December 17, 2008 Subject: **Predelivery Inspection for Other Countries
Outside North America Models
(All Models Except GTX LTD iS and RXT iS)**

No. **2009-2**
REVISION 1
March 20, 2009

⇨ UNDERLINED TEXT(S) BETWEEN ARROWS IS (ARE) ADDED ELEMENT(S) TO THE ORIGINAL PUBLICATION. ⇩

X RS Models<=

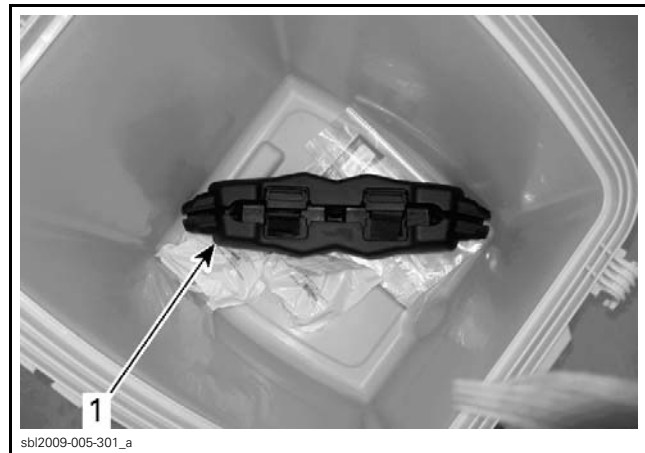
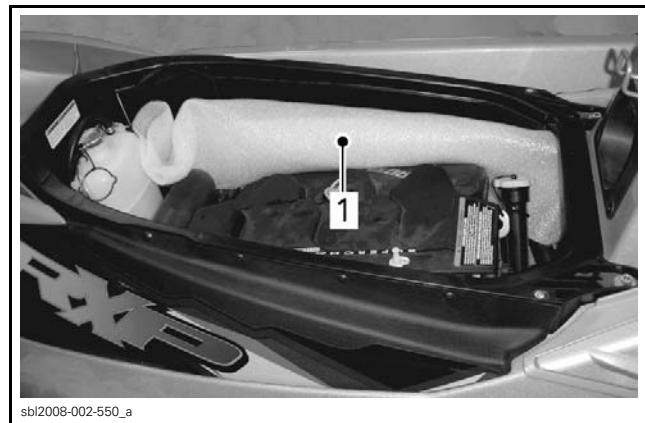
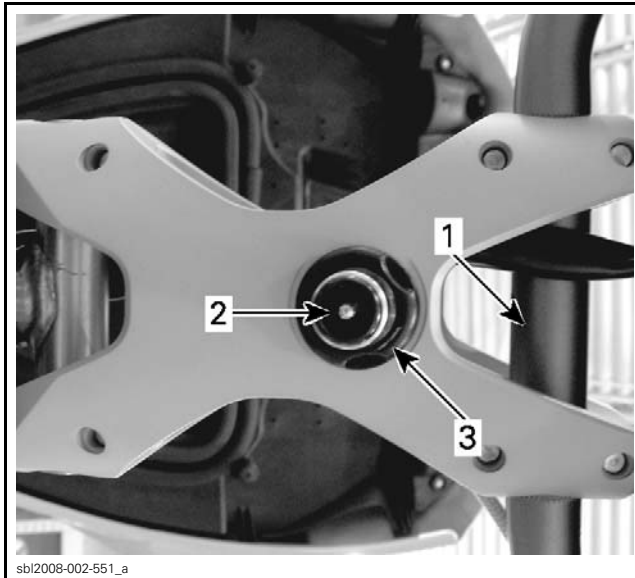
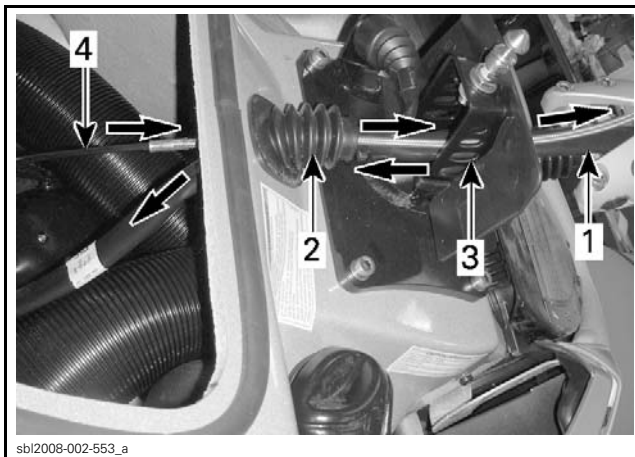
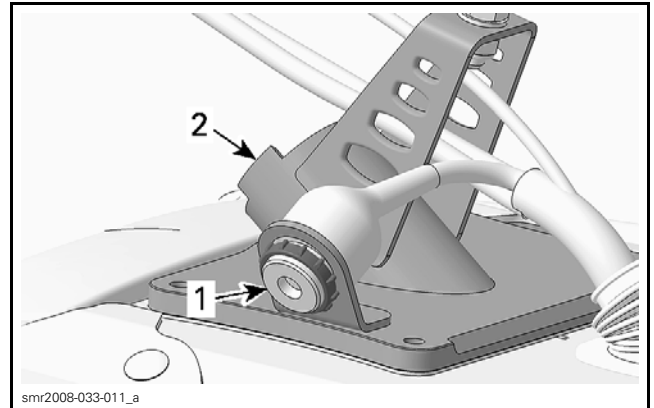
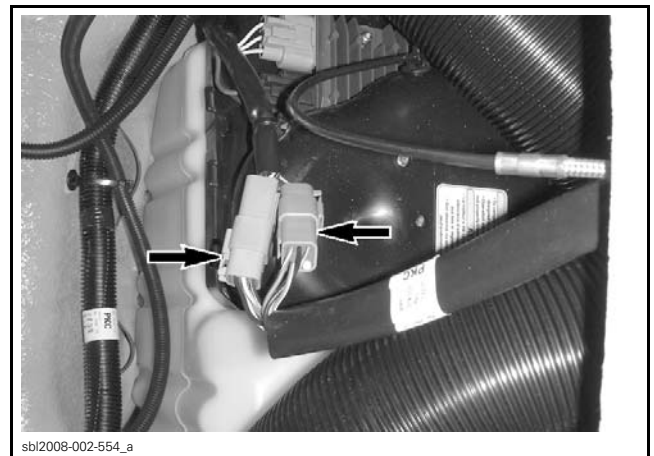
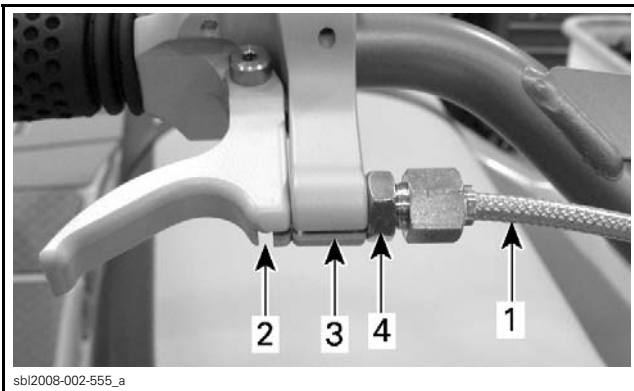
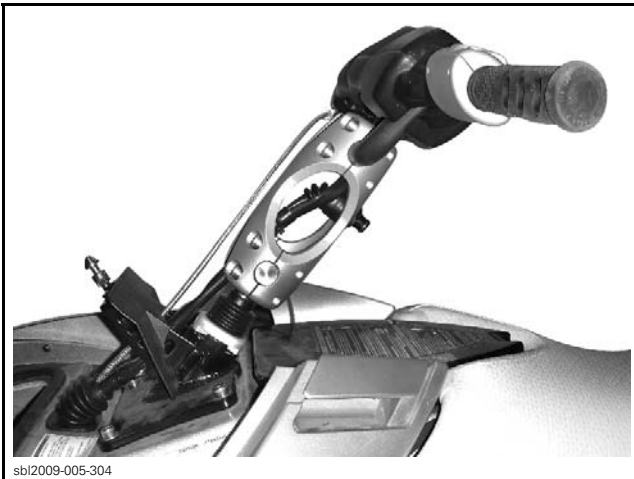
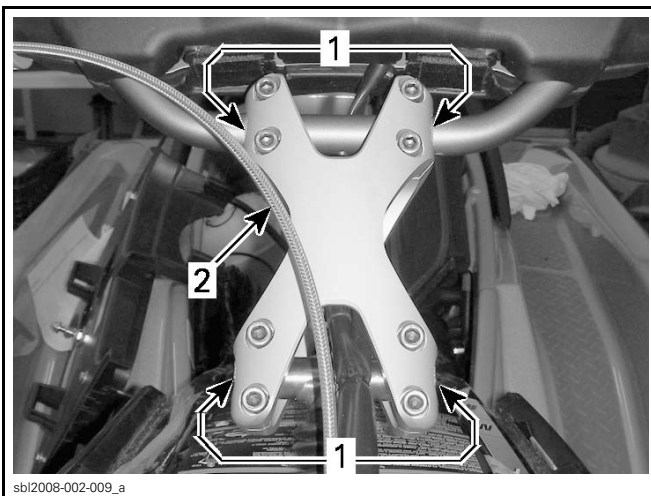
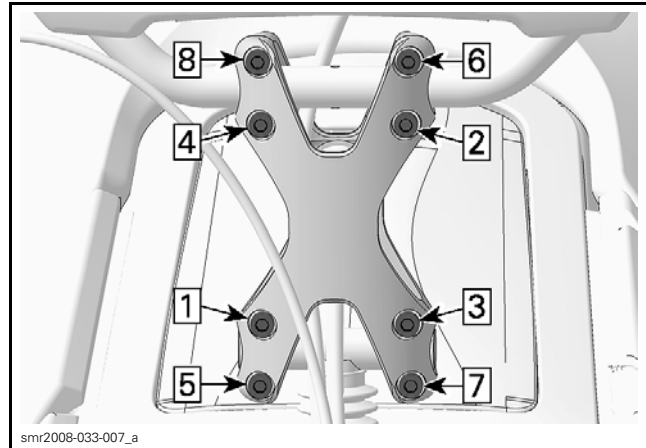
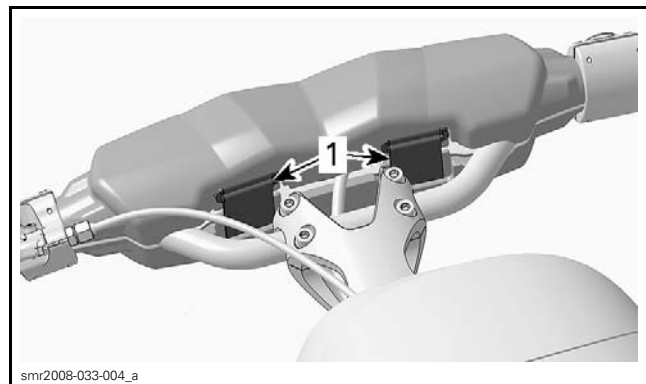
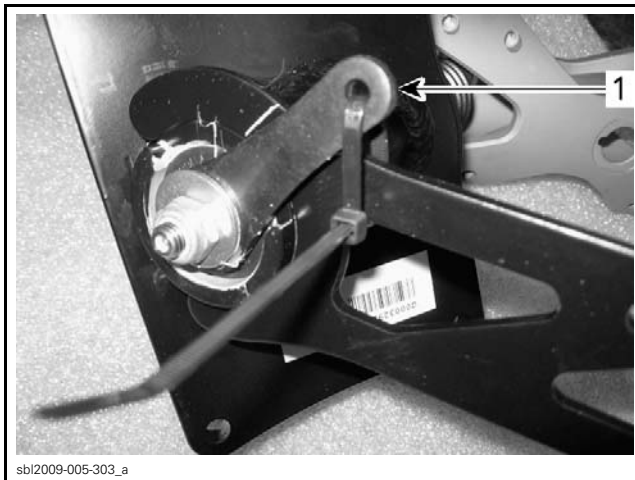
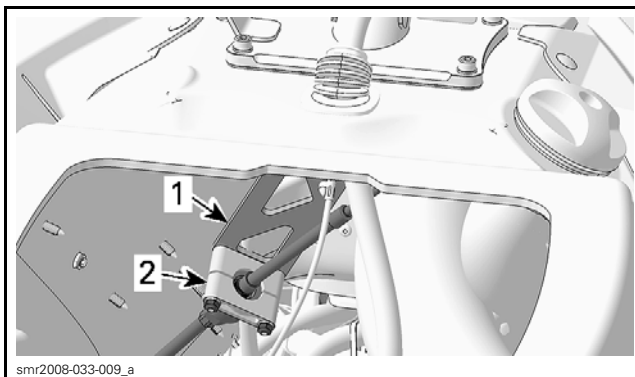
1. ➡ Open front storage cover.
2. Remove storage tray (if so equipped).
3. Remove handlebar padding from storage tray.

8. Install handlebar on riser block with throttle lever on RH side.

10. Torque D.E.S.S. post retaining nut to 1.8 N•m (16 lbf•in).

NOTE: Throttle cable must pass over riser block.

16. Torque retaining nut to 1.5 N•m (13 lbf•in).

22. Torque riser block retaining screws as per the following sequence (refer to the below illustration) :

22.1 Pre-torque the 8 screws to 2.5 N•m (22 lbf•in)

22.2 Then torque the 8 screws to 19 N•m (168 lbf•in)

26.4 Torque nut to 5 N•m (44 lbf•in).

27.4 Do not torque yet, perform steering alignment procedure prior to applying final torque.

NOTICE Steering alignment procedure, described further in this bulletin, must be performed prior to torquing screws from direction cable supports. ←
